# SUPPLEMENT TO DRAFT PROJECT IMPACT REPORT

Submitted to the Boston Redevelopment Authority

Submitted By Tremont Place Realty Trust

21 June 1988

CALCULATED WORST-CASE IMPACT OF PARKSIDE EAST UNIT ON TREMONT-ON-THE-COMMON LIVING SPACES CLOSEST TO PARKSIDE

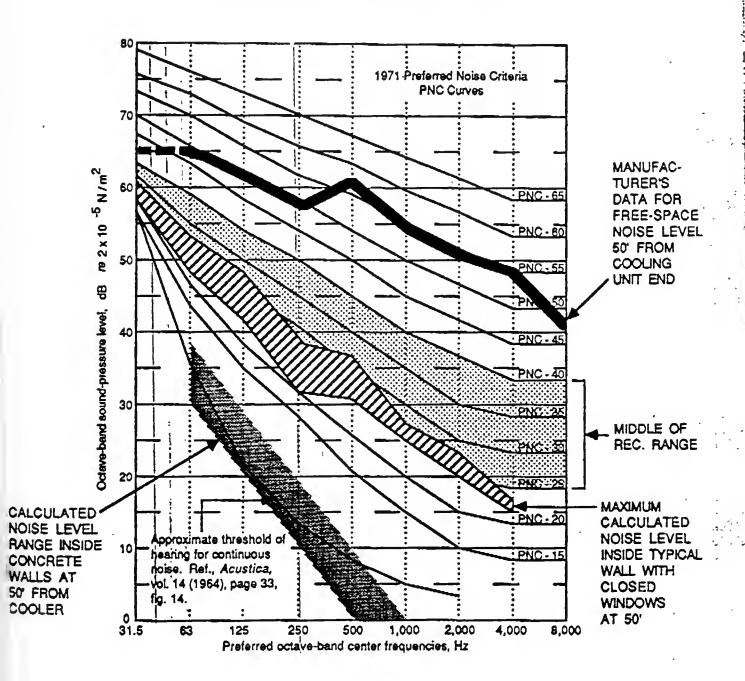
of eight or more inches thick. Using this assumption, the calculated internal noise levels due to the Parkside cooling unit are very low, as shown in the lowest curve on Attachment D. However, the noise transmission through windows will be considerably greater than through the end wall of TOC. To check on a worst case scenario, we assumed that the TOC windows were actually at the location of the Southwest wall only 50 feet from the cooling unit (note that those more distant will be exposed to a lower noise level). Our calculations show that, even in this worst-case scenario, the interior noise levels would fall well below PNC 40, and would thus be acceptable to most residents. The impact on any residential unit on the northwest or southeast facing walls of TOC would be considerably less than that shown below because of; the reduction in noise level which occurs as one moves away from a noise source. For this analysis we have assumed that windows are closed and well sealed. Open windows would of course allow more noise to enter a particular living space, possibly causing the criteria to be exceeded. We also note that persons using balconies might be able to hear the cooling unit above the background noise.

Finally, we note that, if the noise impact of the Parkside mechanical units is ultimately found to be objectionable by a significant number of neighbors, solutions are readily avail- . able in the form of add-on noise attenuation devices.
